Special Council Meeting

| Item 7.3.1 | PROPOSED 44 STOREY MIXED USE DEVELOPMENT - LOTS 2-20 (NO. 74) MILL POINT ROAD, SOUTH PERTH | |

Metro Central Joint Development Assessment Panel Agenda

Meeting Date and Time: 28 April 2016; 10:00am
Meeting Number: MCJDAP/165
Meeting Venue: City of South Perth
Cnr Sandgate Street and South Terrace
South Perth

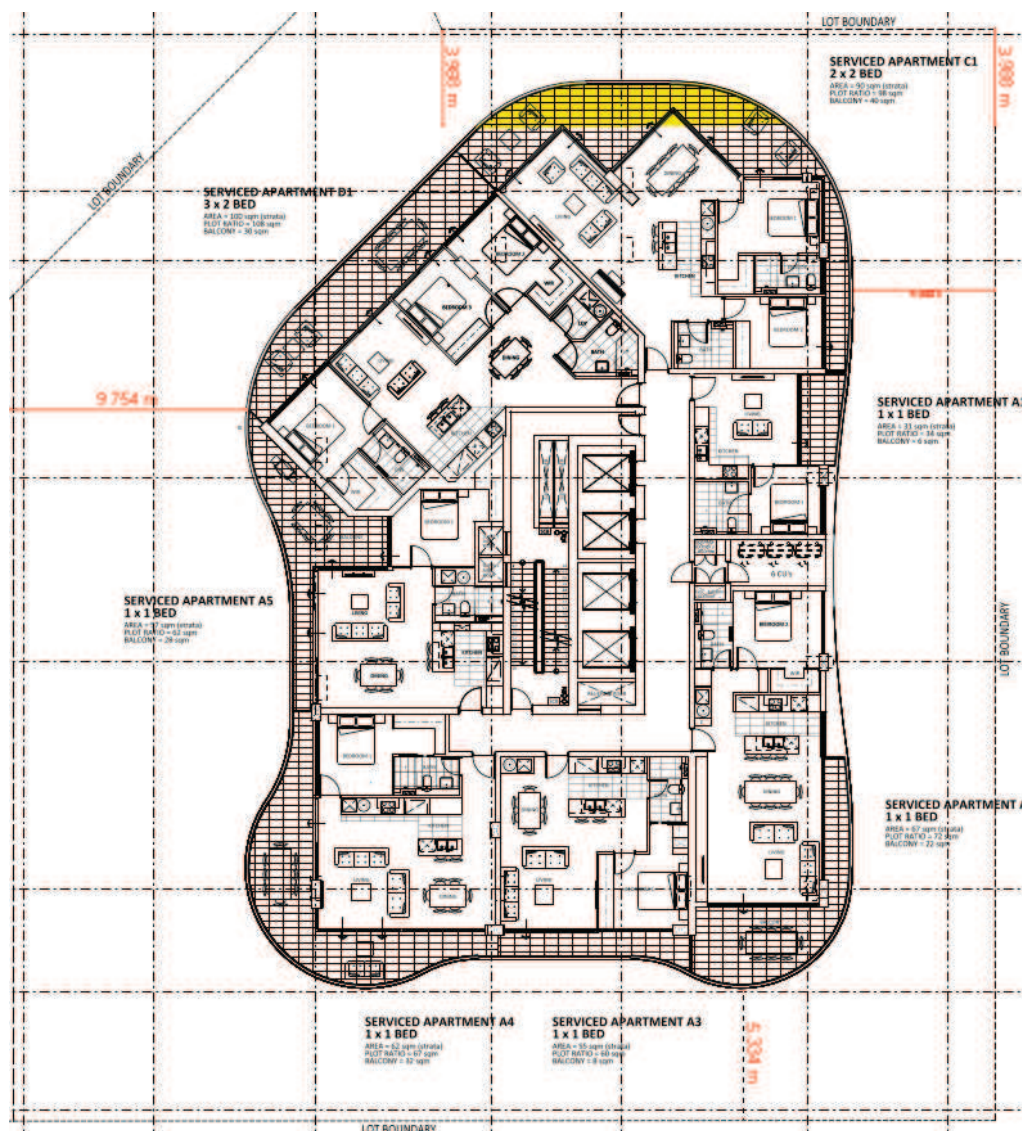
- (i) The nil podium street setback is seen to be inconsistent with proposed Schedule 9A Element 7 Development Requirements. Should this application be approved, it could impair podium setbacks being required Mill Point Road.

- (ii) The proposed change to the permitted podium street setback impacts this application. Whether this element of the Amendment is seen to be consistent with sound town planning principles is unclear, as in responding to streetscape and visual impact concerns, the Amendment could be seen to conflict with the pedestrian amenity and active street frontage objectives for the precinct. The relevant Guidance Statement in the Amendment lists the potential reasons for the increased street setback being related to the larger street setbacks of existing buildings (approved prior to the creation of the Special Control Area) in the same street, a narrow street and/or significant street trees. As discussed above, the street trees are considered to be adequately protected. The gazettal of a change to the required podium street setback is uncertain, as the Council has not yet considered submissions at the time of RAR preparation and the WAPC recommendation and Minister's final decision is unknown. The gazettal of Amendment No. 46 is not imminent, as its final approval is months away.
